## ADDENDUM NUMBER 03

project name:  
**NH Legislative Garage**  
 project address:  
 33 CAPITOL STREET  
 CONCORD, NH

Project name:  
**New Legislative Parking Garage**  
State Project Number: 81284-B  
Project Address:  
33 Capitol St.  
Concord, NH 03301

**1 JOINT DETAILS FOR REINFORCED S-O-G**  
 S-005 SCALE: 3/4" = 1'-0"

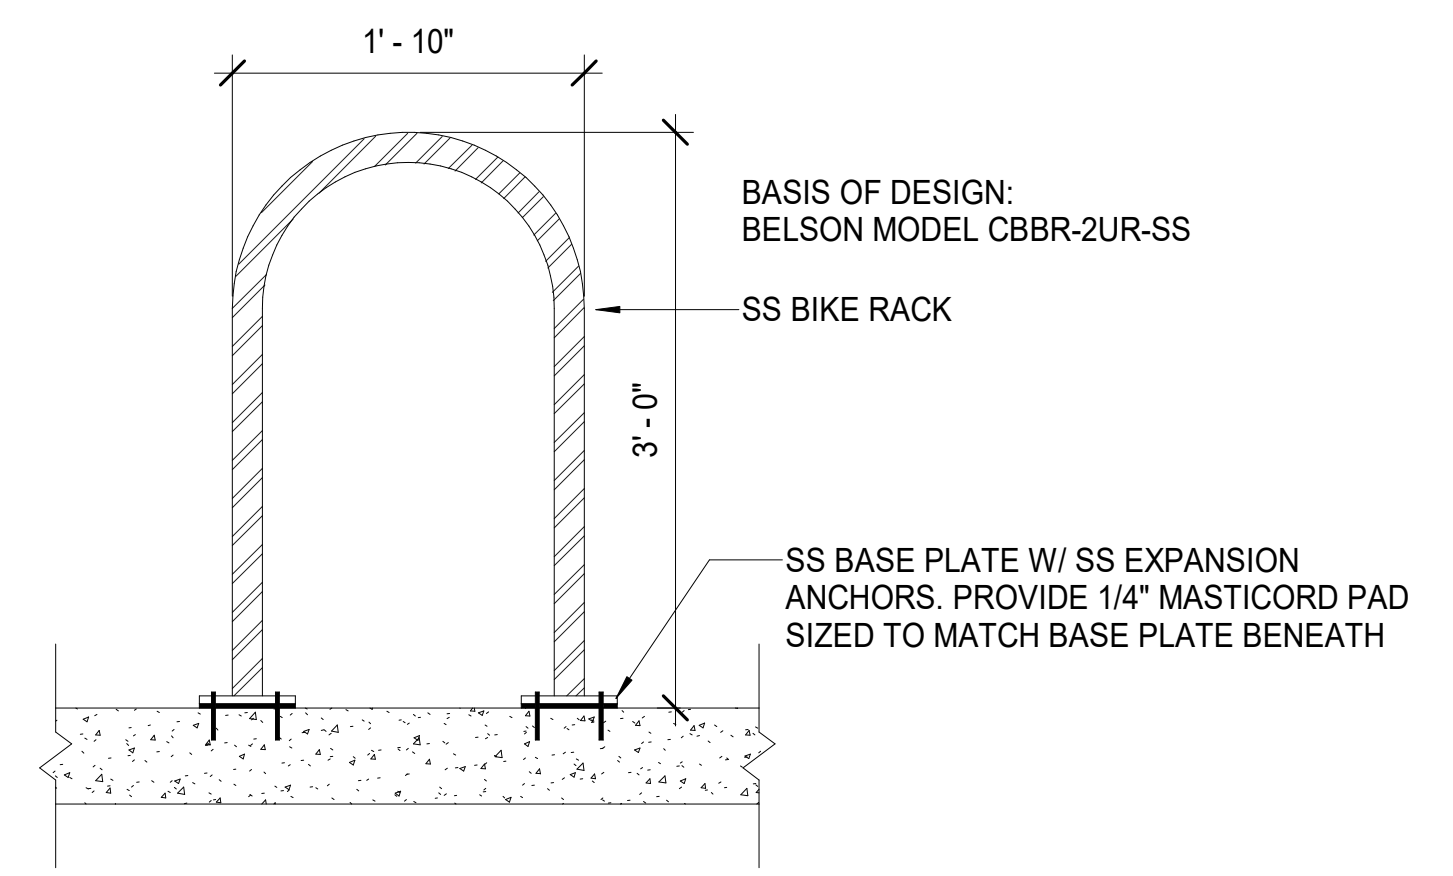
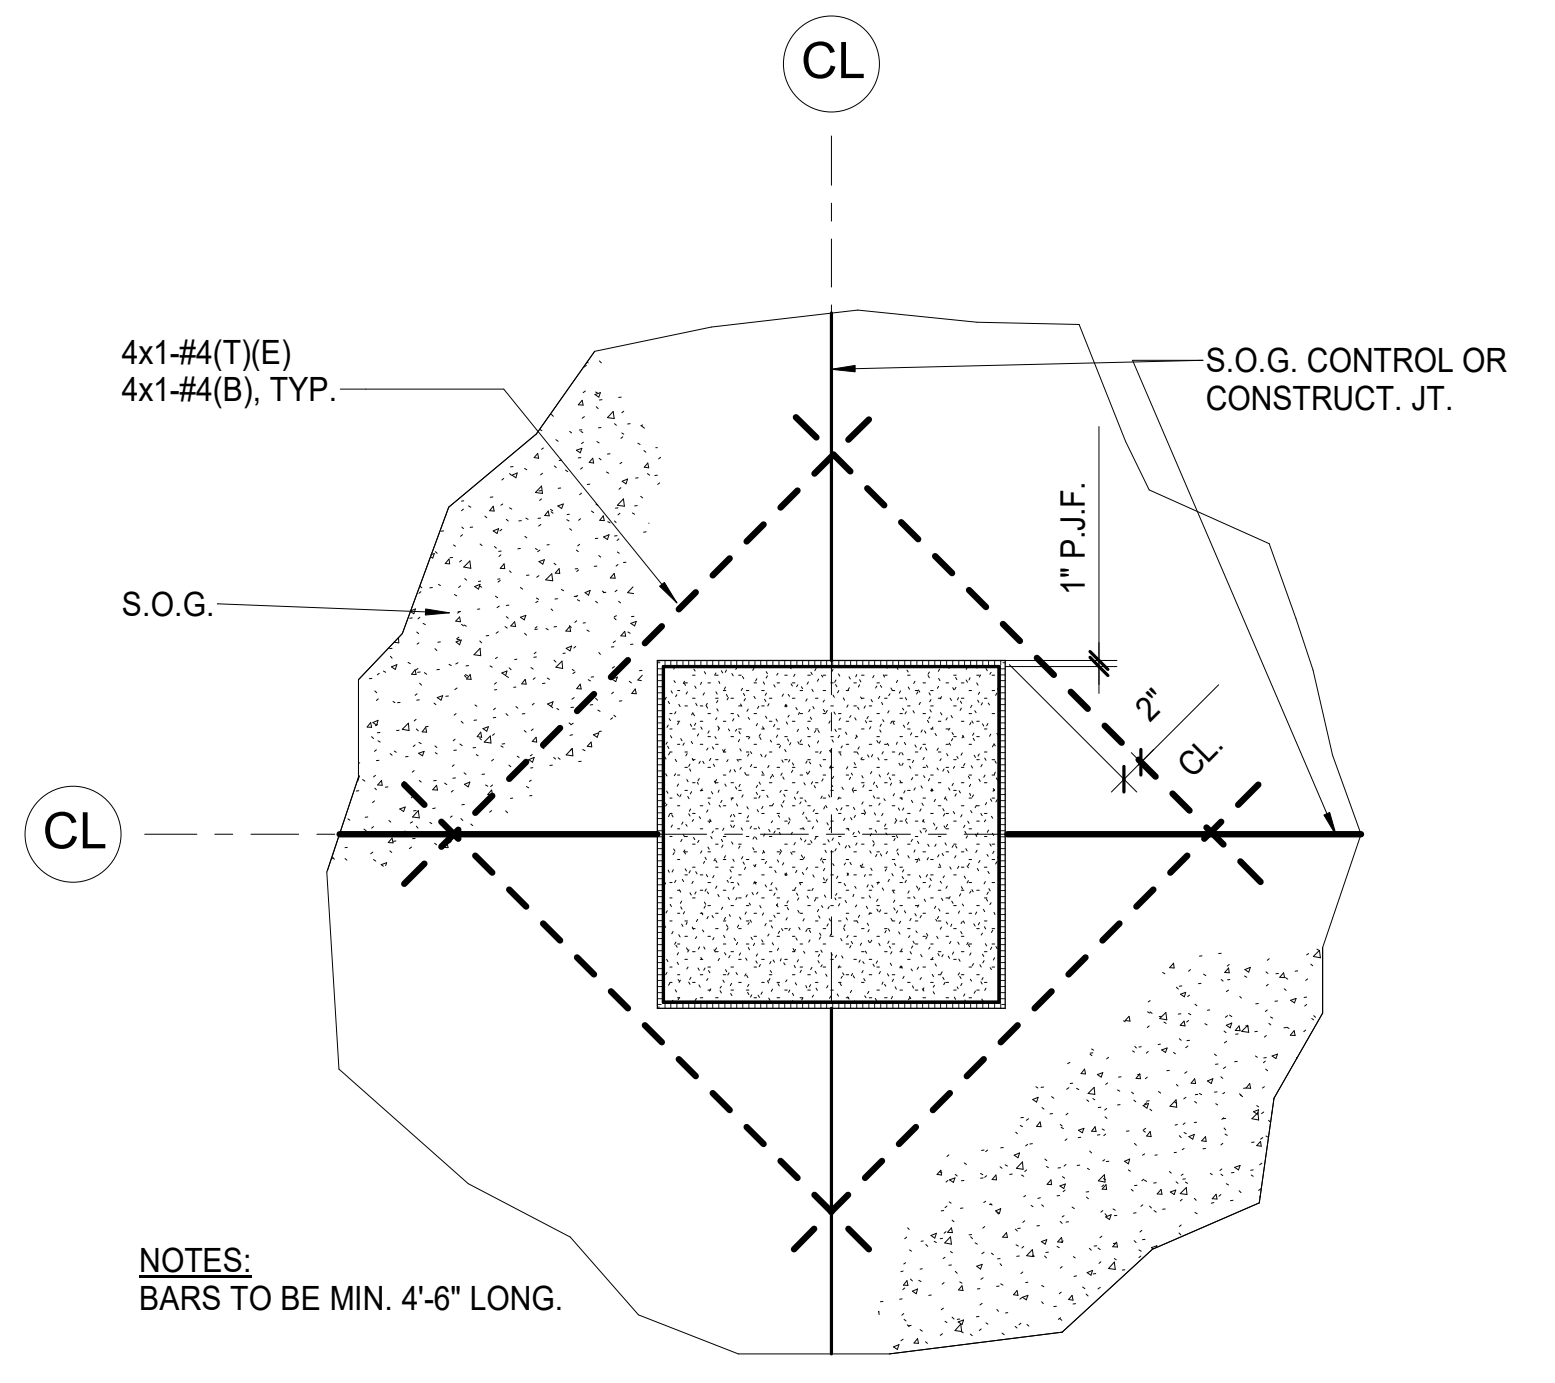
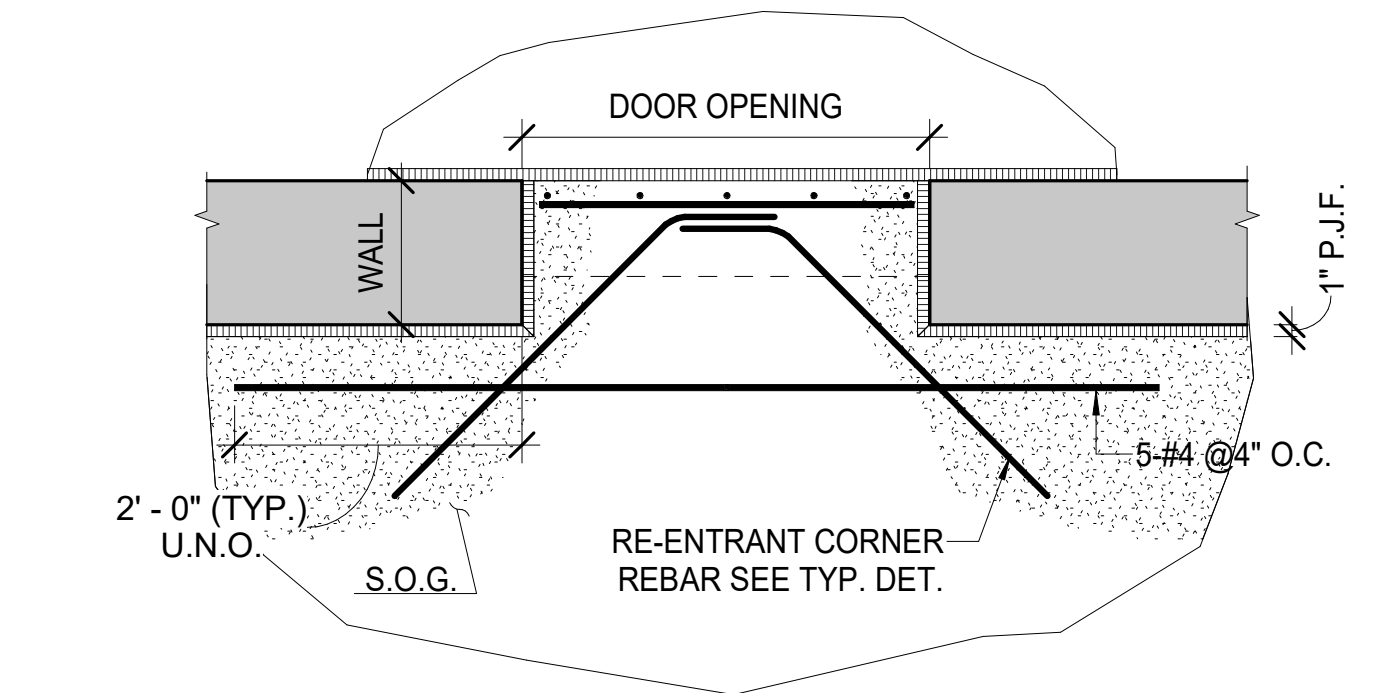
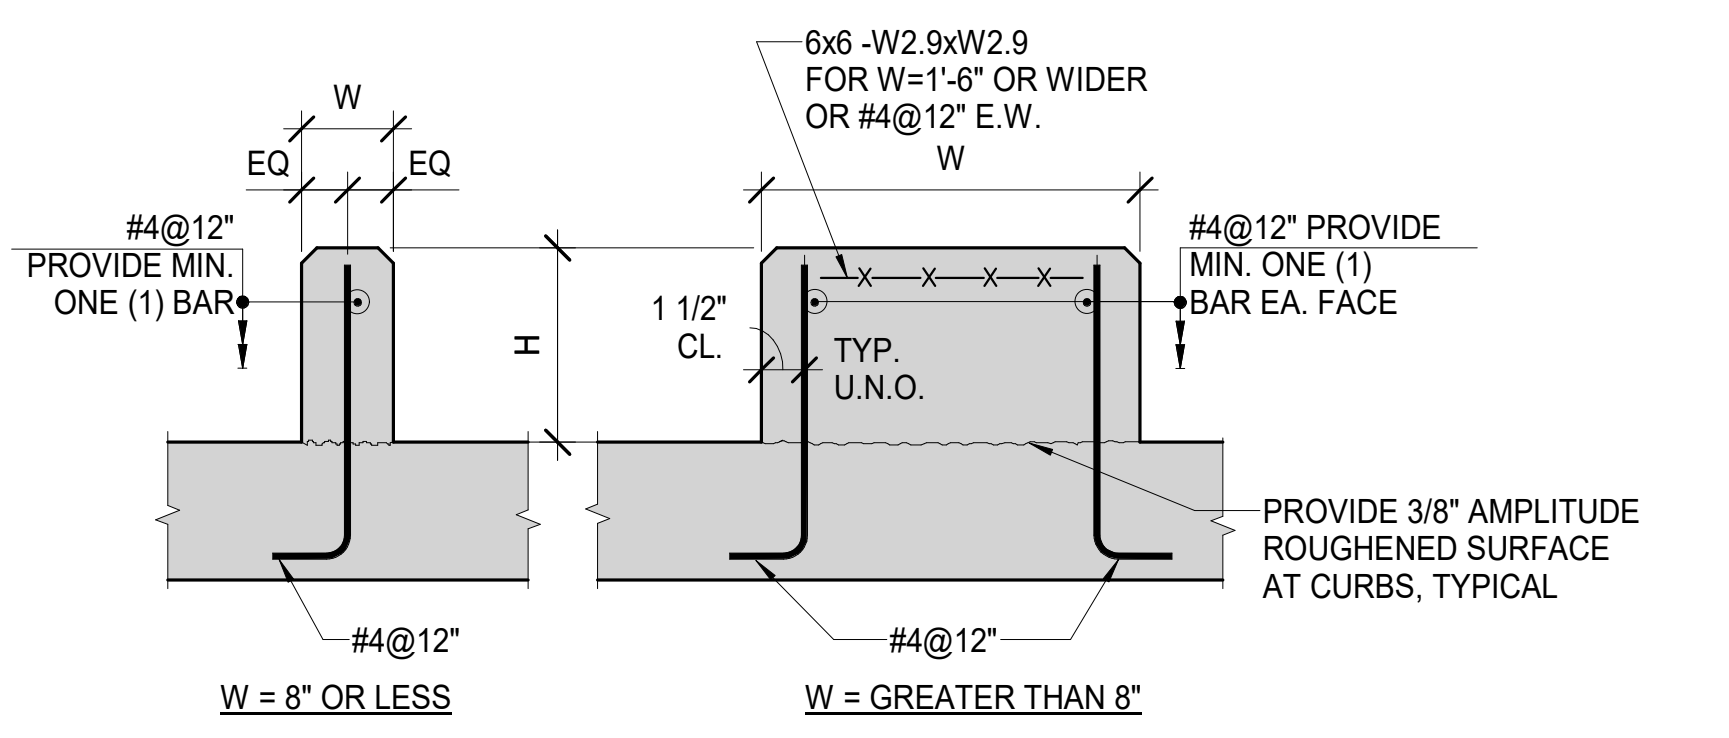
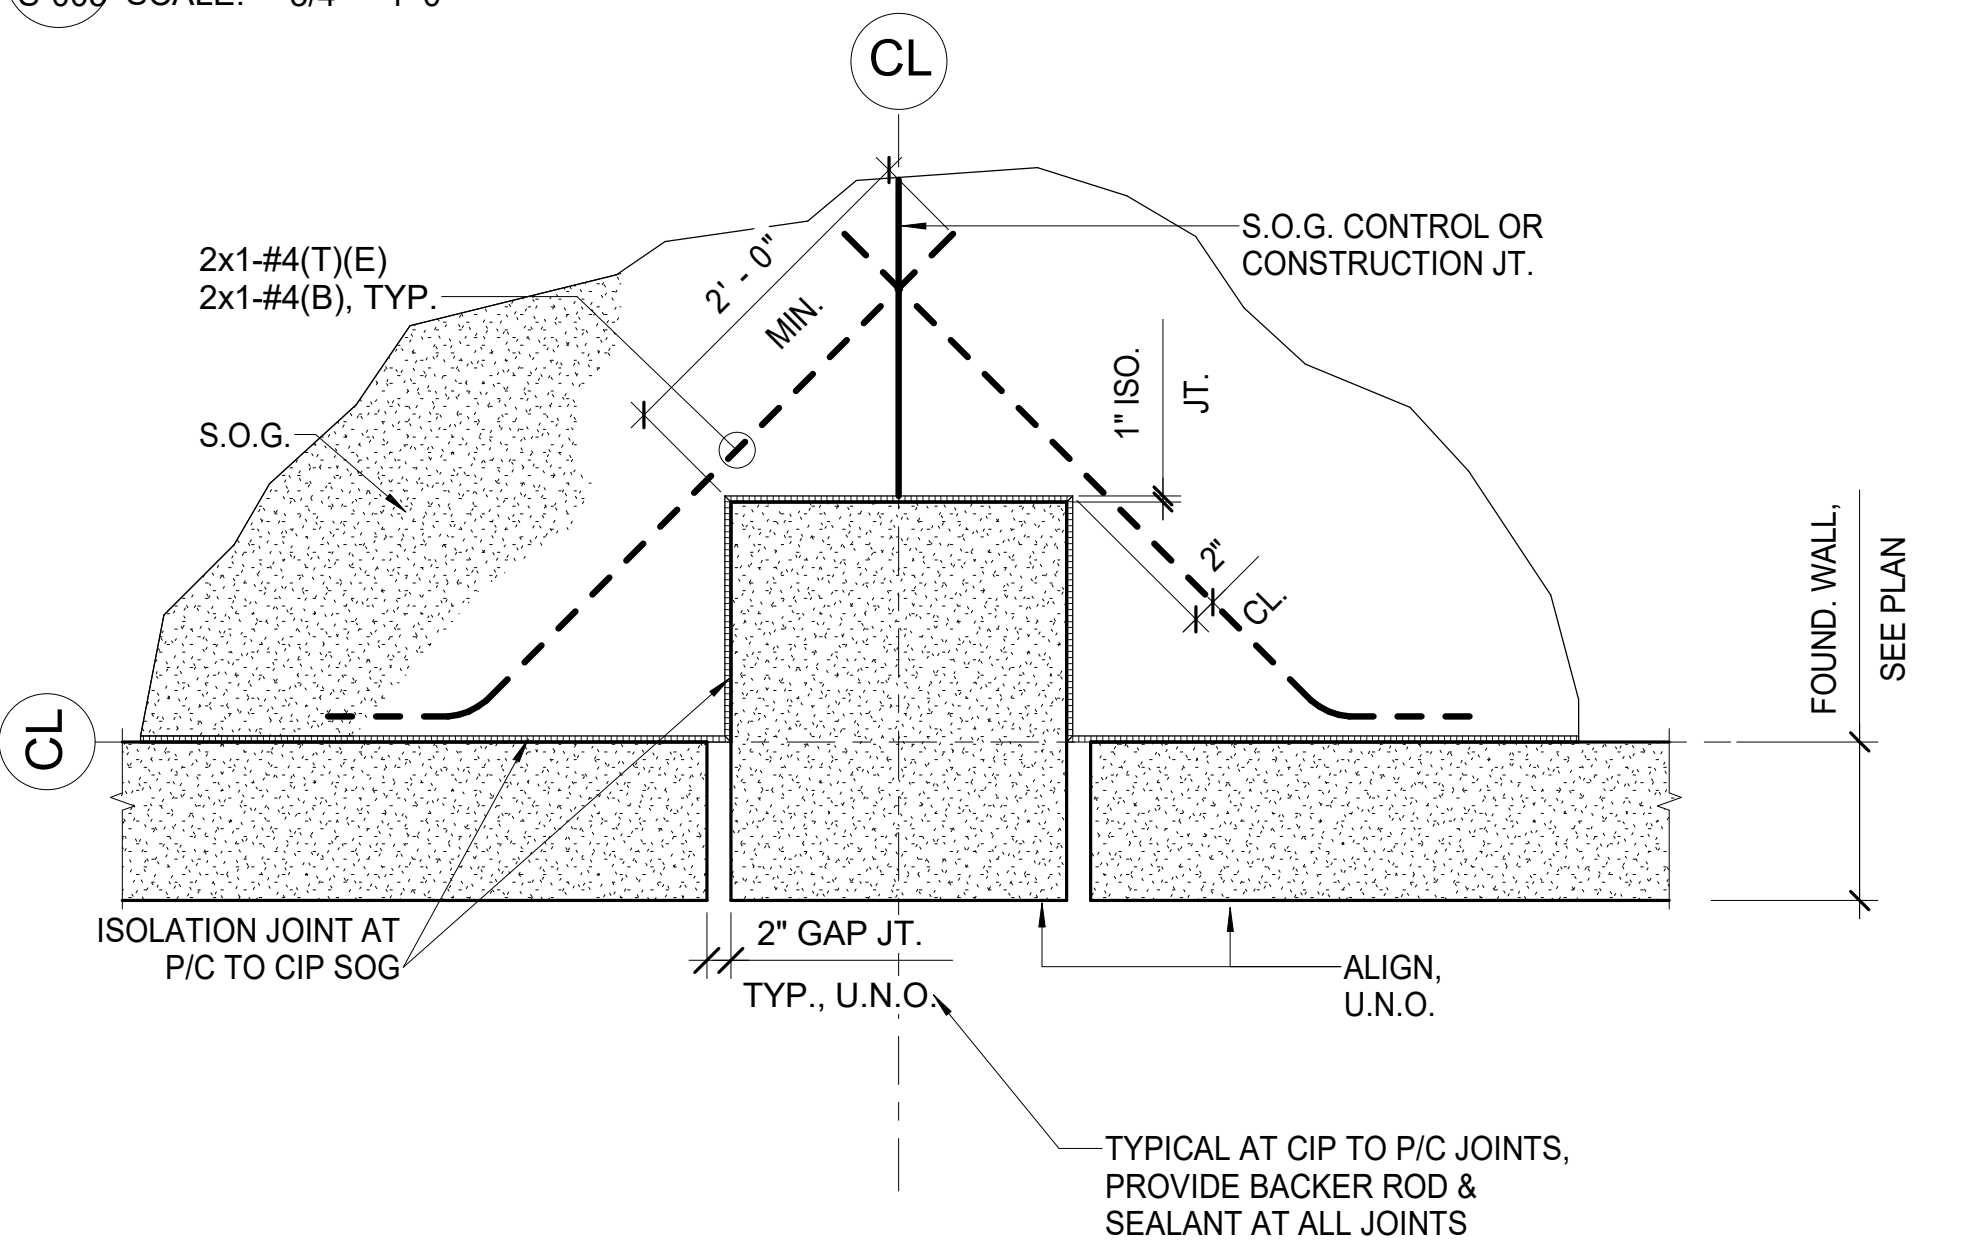
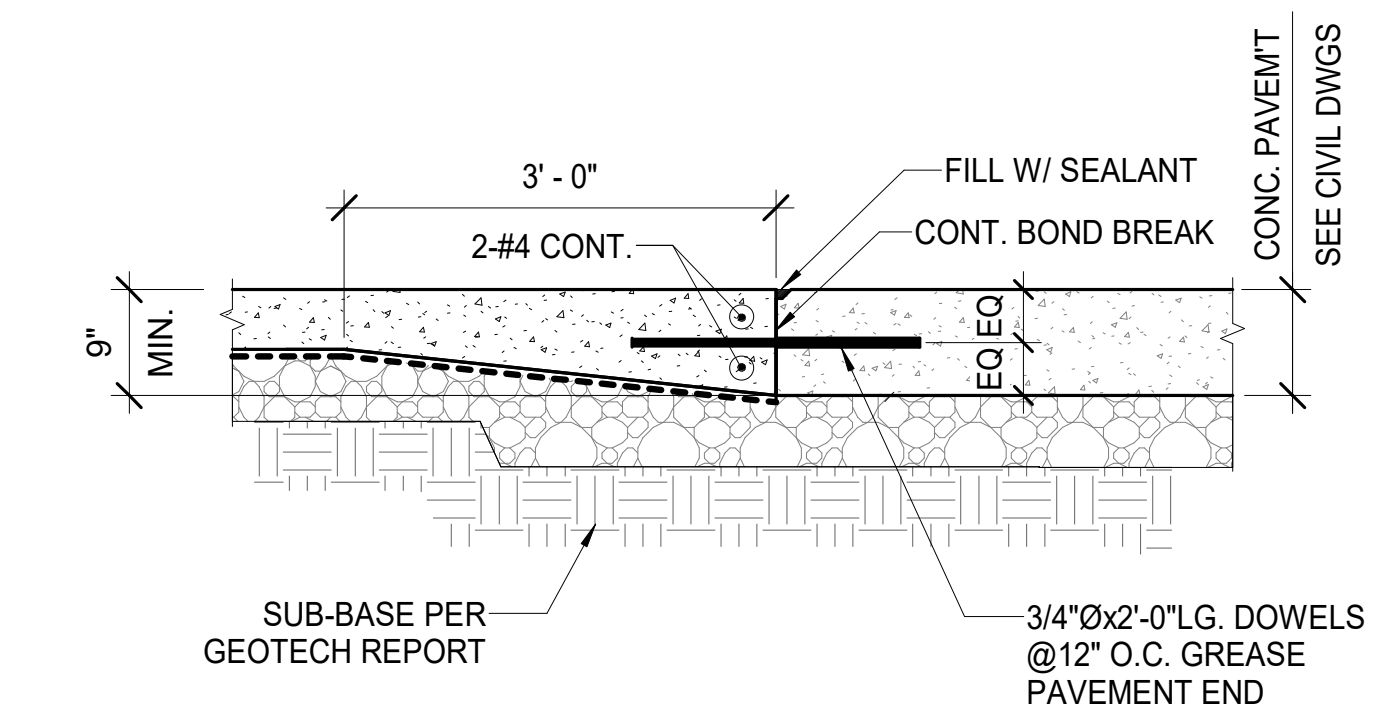
44. Q: Please confirm our interpretation of detail 1 on S-004 "Typical Ground Improvement Detail": GC to provide Option 1 or Option 2 as follows: Option 1: Sitework contractor to excavate entire building SOG footprint and provide structural fill down 4' to frost line. Sitework contractor to provide 12" of crushed stone under entire building SOG footprint No rigid insulation required. Option 2: Sitework contractor to provide 12" of crushed stone under entire building SOG footprint Provide 2" rigid insulation under entire SOG footprint. Sitework contractor DOES NOT NEED to excavate entire building SOG footprint and provide structural fill down 4' to frost line.

- A. Over the entire SOG area provide either: 12” of Crushed Stone over Structural Fill to frost depth (4'-0" below slab on grade) or 12” of Crushed Stone over 2” of rigid foam insulation.
